Work Order ID 92858

Item Name: Crosstube Turning Detail

DART AEROSPACE LTD		Work Order:	9285E
Description: Crosstube Assembly (205/212/412 High Fwd)		Part Number:	D212-664-141
Inspection Dwg: D212-664-141 Rev: D		Page 1 of 2

DRAWING NO. D212-664-141	TITLE XTUBE ASSY (205/212/412 HI FWD)	REV. D	DART AEROSPACE LTD ENGINEERING ORDER		D.E.O. NO. D212-664-141-D-1	SHEET NO. SHEET 1 OF 2	SCALE NTS
DRAWN	CHECKED	MFG. APPR.	APPROVED	DE APPR.			
DATE 11.04.07	DATE 11.04.11	DATE 11.04.12	DATE 11/04/12	DATE 11.04.12

**D212-664-141/-141B
ASSEMBLY DETAIL**

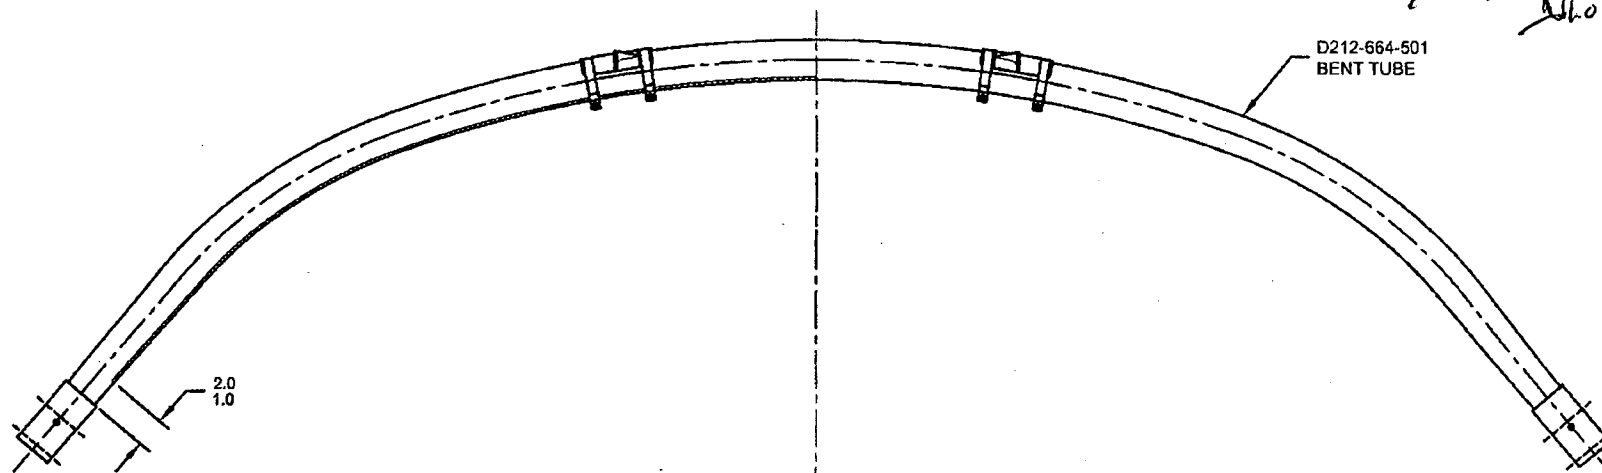
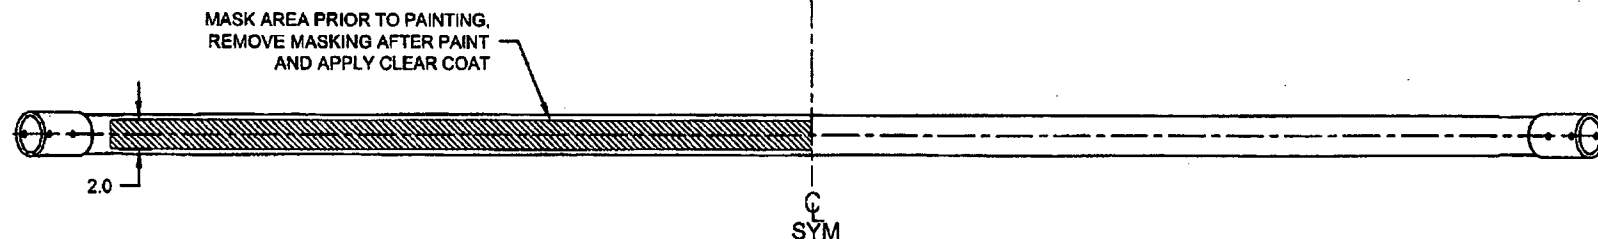
PURPOSE:

ADD AN INSPECTION WINDOW TO UNDERSIDE OF CROSSTUBE.

IS:

WAS:
